SOUTH COAST AIR QUALITY MANAGEMENT DISTRICT

# Comments and Responses to Comments

## 2016 AIR QUALITY MANAGEMENT PLAN

March 2017

Figure 7. Slide No. 6 from SCAQMD’s presentation Item 3b from the October 26, 2016 STMPRAG meeting (Source: SCAQMD, 2016).

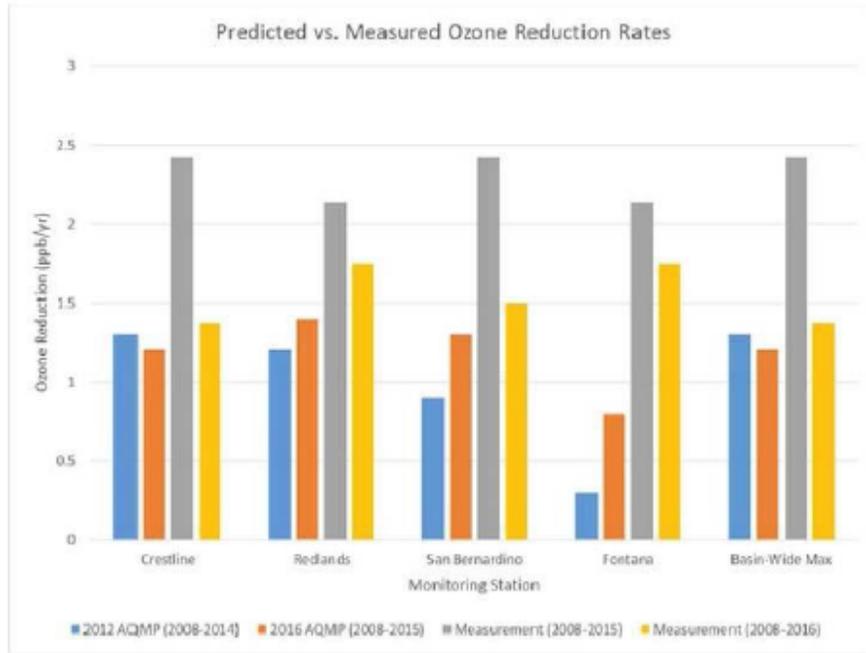
The final slide from SCAQMD's presentation compares 5-yr DV ozone reduction rates at four sites plus the basin-wide maximum for: (1) the 2012 AQMP CMAQ 2008 model and the 2008-2014 time period; (2) the draft 2016 AQMP and CMAQ 2012 model and the 2008-2015 time period; (3) measured ozone for the 2008-2015 time period; and (4) measured ozone for the 2008-2016 time period. It appears that the SCAQMD's point in presenting this slide is that the measured ozone trend reduction rate over the 2008-2016 time period is more like the modeled values over the 2008-2015 time period. The problem with the SCAQMD analysis is that they are using observed ozone trends based on observed 2015 and 2016 5-yr DV ozone values that don't yet exist. The 2015 5-yr ozone DV is based on observed ozone concentrations from 2013-2017, which includes the year 2017 that has not yet occurred. Similarly, the 2016 5-yr DV uses observed ozone from 2014-2018 that includes two years (2017 and 2018) that have not yet occurred. Since ozone observations for 2017 and 2018 do not exist, we cannot reproduce the SCAQMD's analysis. Rather, it appears that the SCAQMD made an assumption that the 2017 and 2018 meteorological conditions and resultant ozone concentrations would be between the ozone levels in 2014 and 2016 to prepare figures to make the point that the observed ozone trend is getting closer to the modeled ozone trend. However, this type of assumption is not warranted given that the 2016 meteorology was in the top 0.5% of ozone formation potential conditions; it is essentially assuming that ozone formation conducive meteorological conditions occur in 2017 and 2018 that approach the unusual 2016 meteorological conditions would occur three years in a row.

Rather than relying on highly unlikely extrapolated values for ozone in 2017 and 2018, we will continue to base our discussions on actual recent year observed ozone values. Figure 8 compares the modeled and observed 5-yr DV ozone reduction rate at four sites plus the basin-wide maximum using ozone observations as far out as currently available (i.e., the 2014 5-yr DV based on 2012-2016 observations). At Crestline, the observed rate of ozone reductions is almost twice as high as the modeled rate, and the basin-wide rate of 5-yr DV reductions is over 50% faster than the modeled rate. This holds even when using the unusually high 2016 ozone season as the ending year anchor point in the observed ozone trend.

**Figure 1.** Observed and modeled ozone Design Value (DV) trends at Crestline using the 3-yr DV (top) and 5-yr DV (bottom), and the draft 2016 AQMP CMAQ 2012 modeling platform using observed trends through 2016 ozone season data.

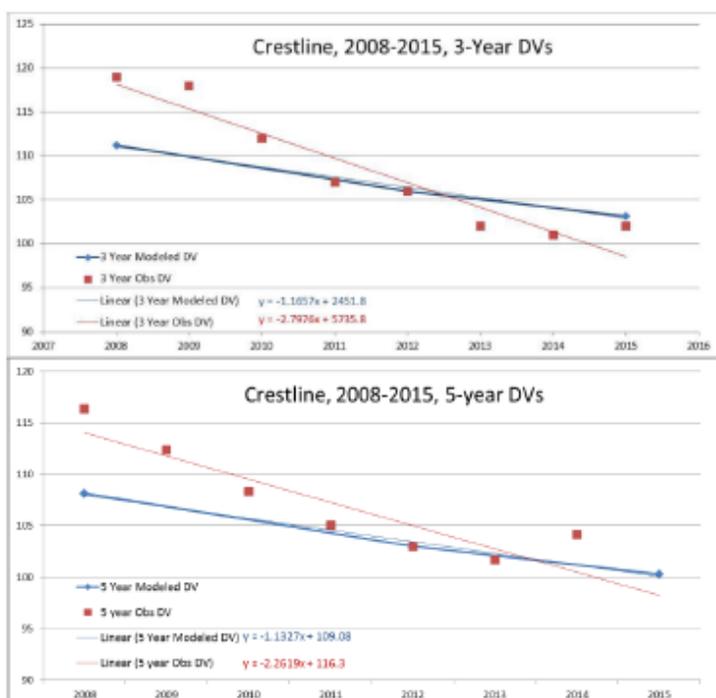
As explained more fully in the comments being submitted by the Truck and Engine Manufactures Association (“EMA”), Ramboll’s dynamic evaluation involved CMAQ simulations using historical emissions over approximately 25 years (1990–2015) in order to compare observed and modeled ozone trends over time. Figure 1 (below) presents Ramboll’s dynamic model evaluation comparing observed ozone trends at Crestline, which generally corresponds to the historical Basin-wide maximum ozone design value, with the relevant modeling database for the period of 2008 to 2015. Even when factoring-in the unusually high observed ozone level from 2016, the rate of the modeled ozone reduction trend is still at least a factor of 2 lower than the observed trend. (*See* Table 1, below.)
